Report to Norwich Highways Agency Committee

24 November 2016

Subject Transport for Norwich – Eaton and Cringleford area

Working Group – Questions and Feedback Report

SURVEYED BY	INITIALS	DATE	DRAWING No.
OS	OS	10/16	PE4118-HP3-011
DESIGNED BY	AW	10/16	PROJECT TITLE
DRAWN BY	JM	10/16	PE4118 Eaton & Cringleford Preliminary Consultation Plan
CHECKED BY	BF	10/16	SCALE
			1:500
			FILE No.
			PE4118

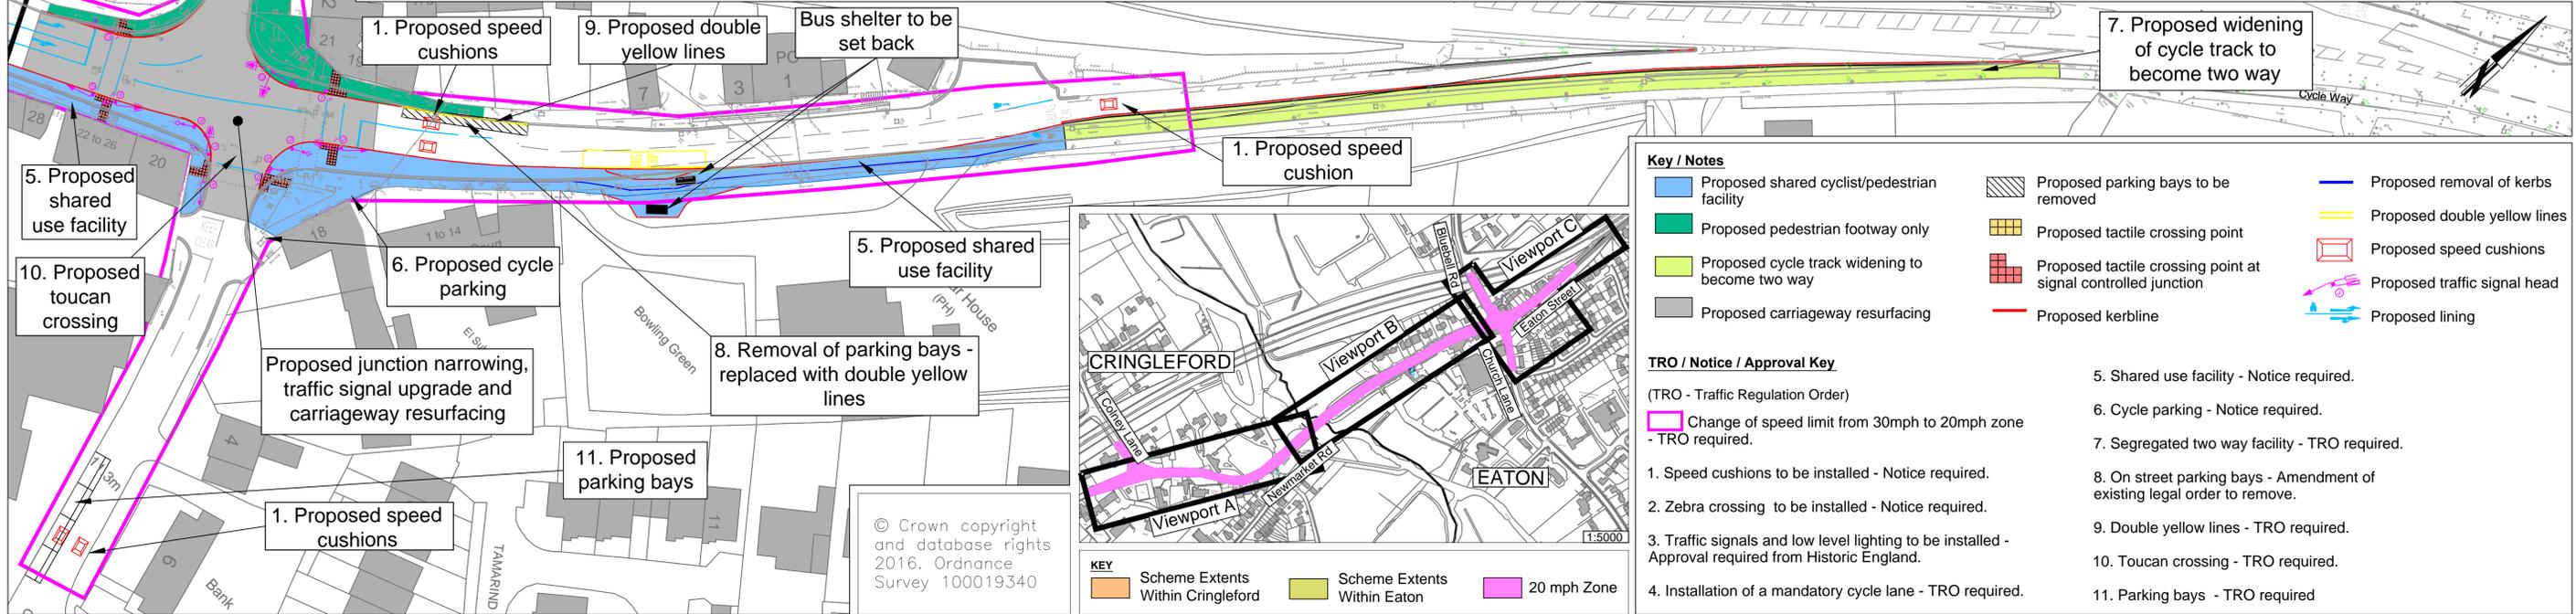
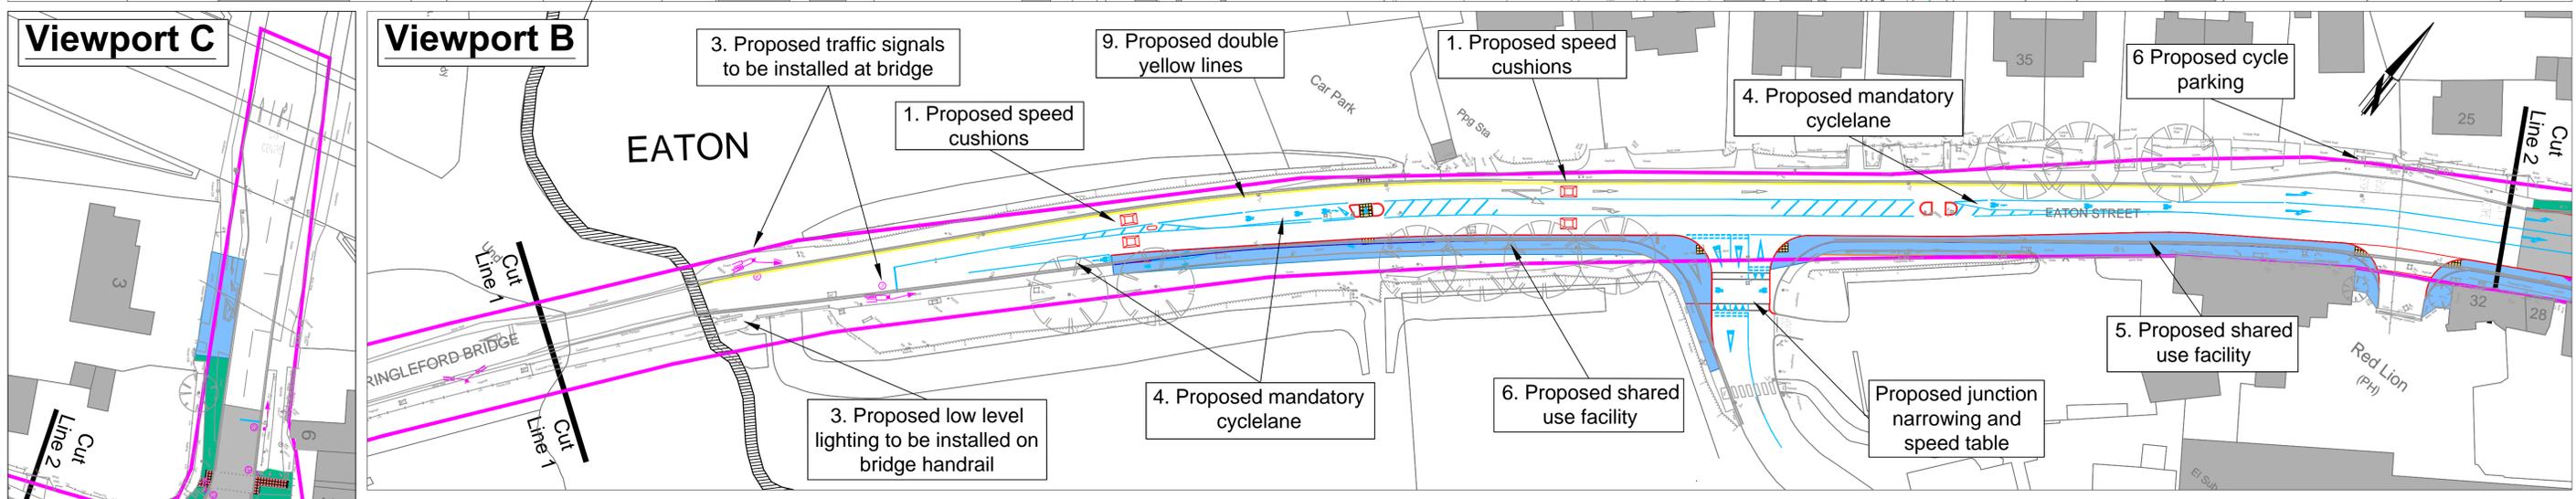
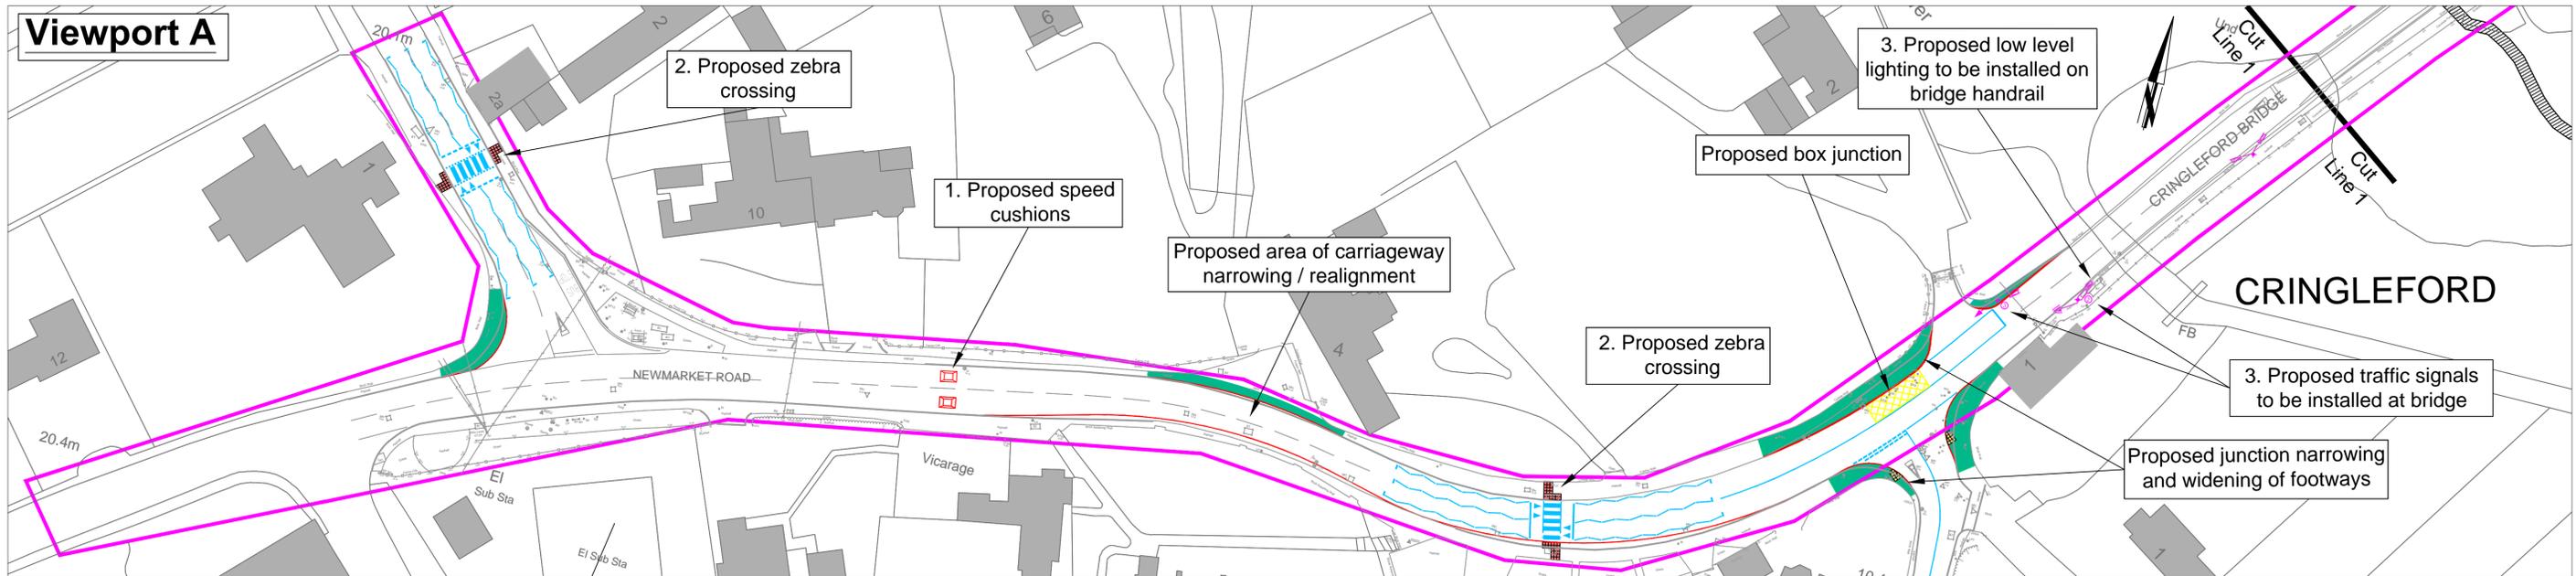
4. Ask the Head of city development services to carry out the necessary statutory processes to complete the following Traffic Regulation Orders as shown on Plan No. PE4118-HP3-011 attached in Appendix 1 which have the effect of:

- Retaining the existing parking area on Eaton Street outside the old Post Office, increasing the maximum stay to two hours.
 - Installing double yellow lines on the remainder of the slip road and extend these further into Eaton Street.

- Providing four new parking bays opposite to Barclays Bank on Church Lane as alternative parking to the parking bays removed from Eaton Street.
 - Introducing a 20mph Zone along Newmarket Road, Cringleford and Eaton Street, Eaton extending into the junctions of Bluebell Road, Church Lane and Colney Lane, the effect of which is that no vehicle, other than an emergency vehicle, may proceed at a speed in excess of 20 miles per hour on those roads.

- Providing short sections of mandatory cycle lanes centrally in the carriageway to enable right turning and ahead movements by cyclists travelling east and an on-carriageway cycle lane for cyclists travelling west towards Cringleford Bridge.

- Providing for the shared cycle/footway facility and segregated cycle path on Eaton Street and a shared cycle footway on Bluebell Road on Bluebell Road.

Eaton Village Centre proposals

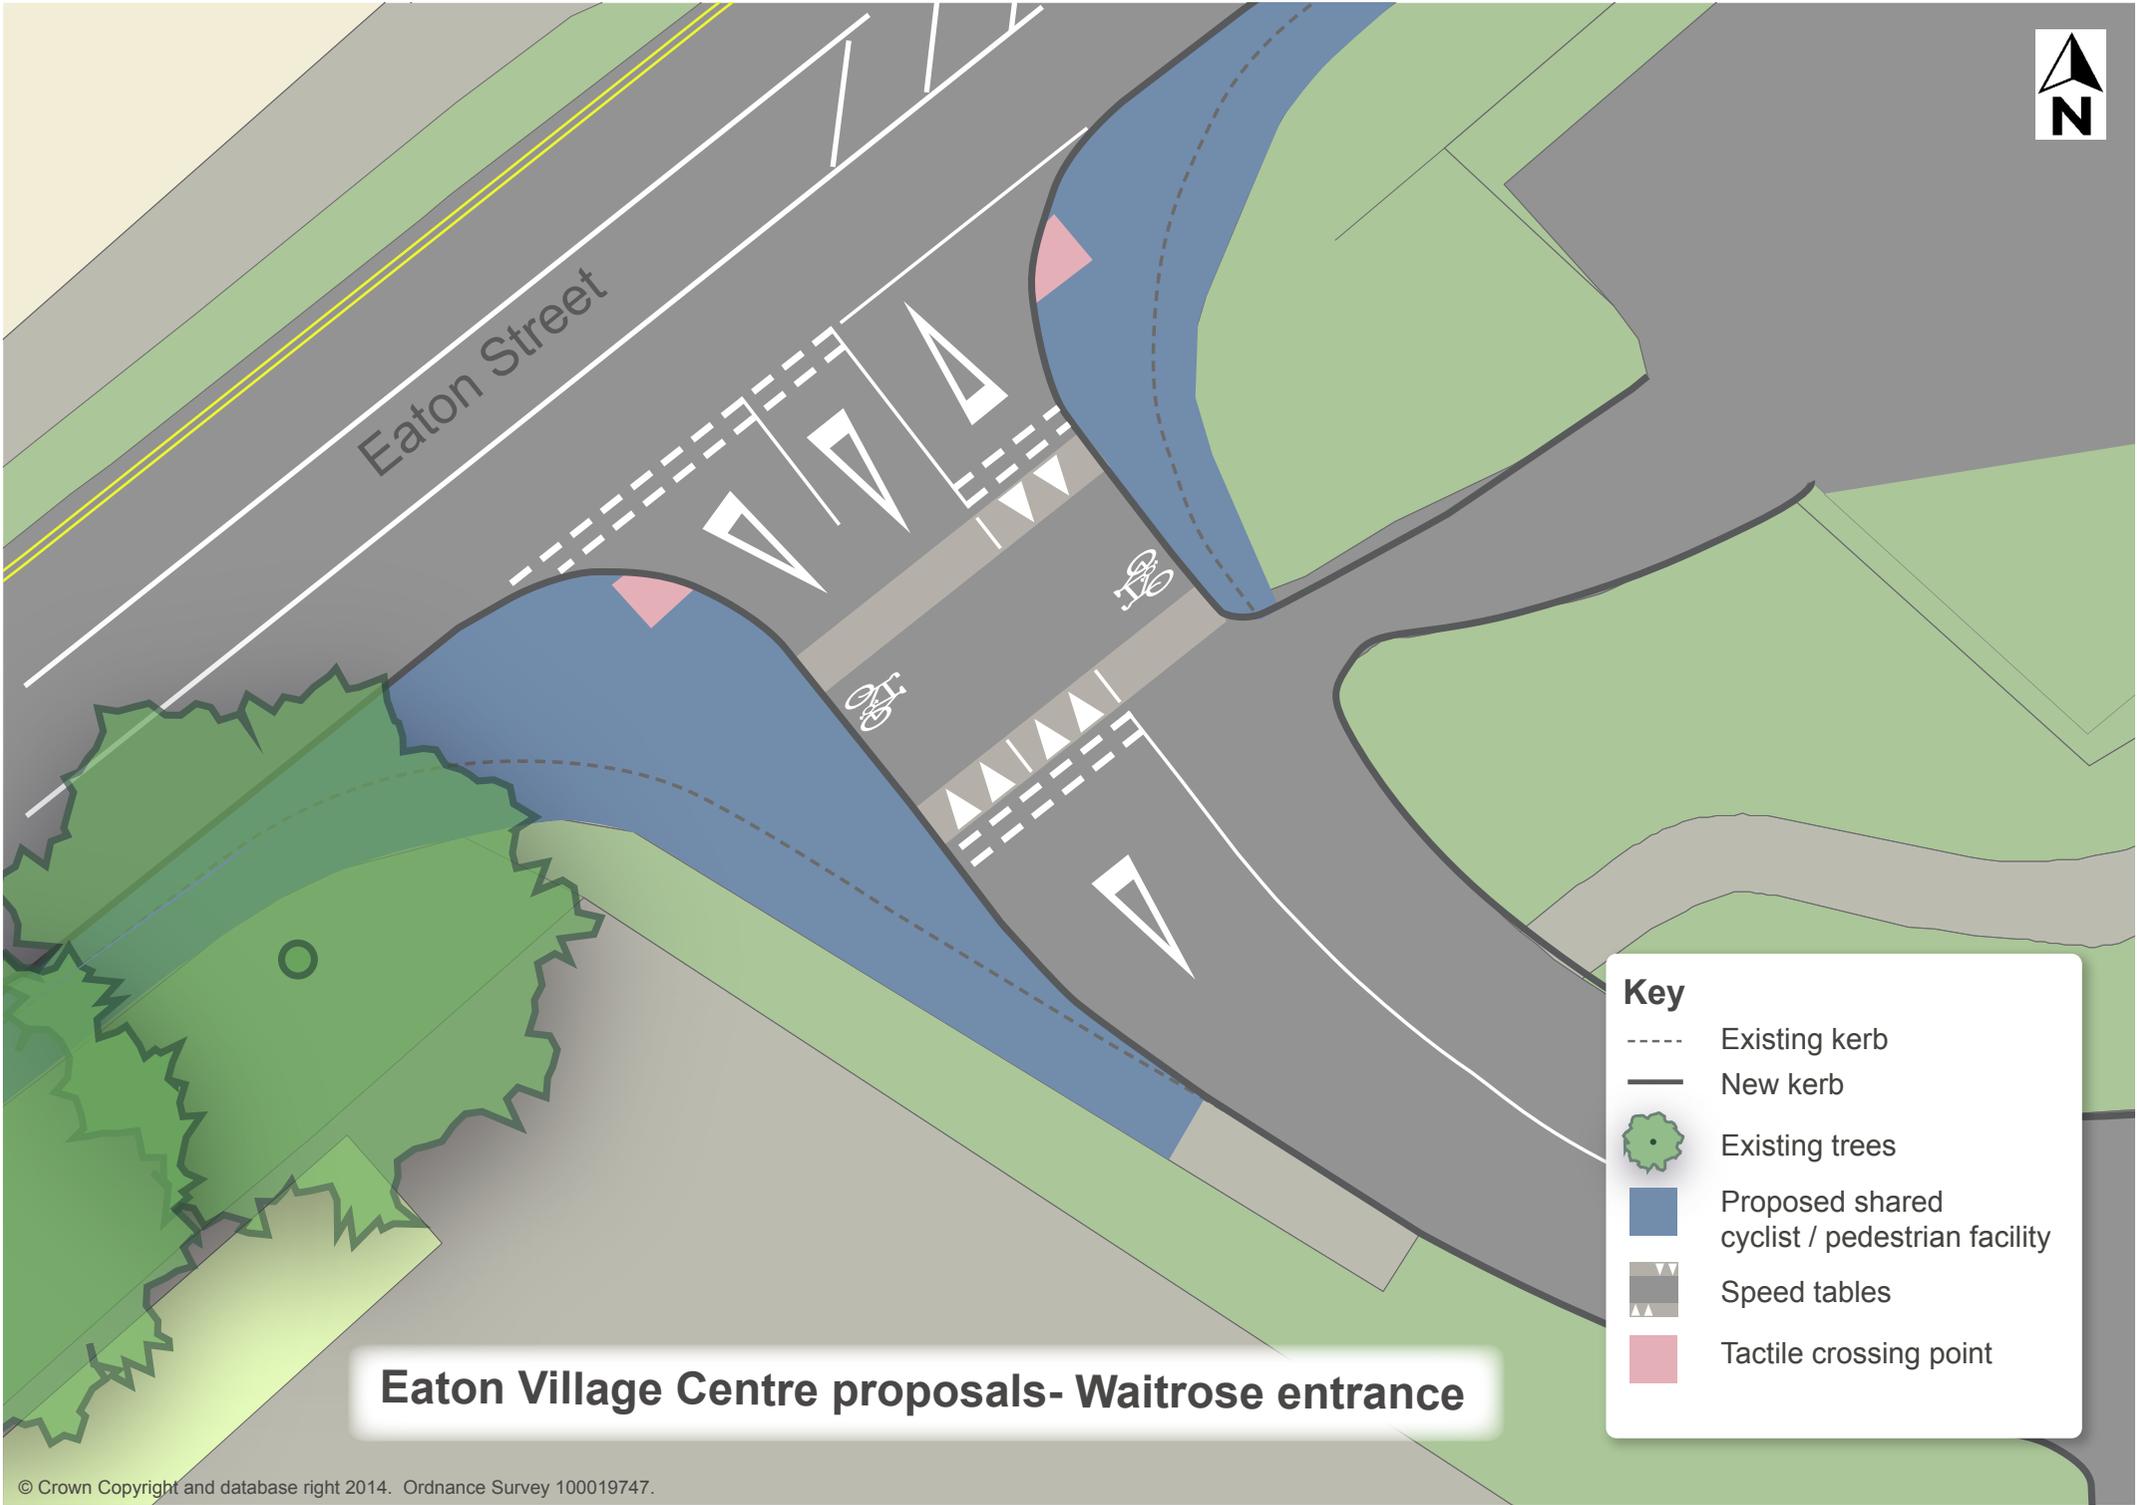
NOTE TBC - Bluebell Rd cyclepath to be enhanced as part of separate scheme

Redundant signs and street furniture to be removed to enhance appearance of space

Removal of parking on north side of Eaton Street

NOTE TBC - Widen cycle track up to new signal controlled crossing to allow two way use by cyclists

Bus shelter to be set further back in verge

Proposed speed cushions

Widened path converted to shared-use

Cyclists rejoin carriageway

Shorter pedestrian crossing - central island removed

shorter pedestrian crossing

Raised landscaped area to incorporate repositioned village sign, seat and public transport information

Shared cycle and pedestrian crossing (toucan)
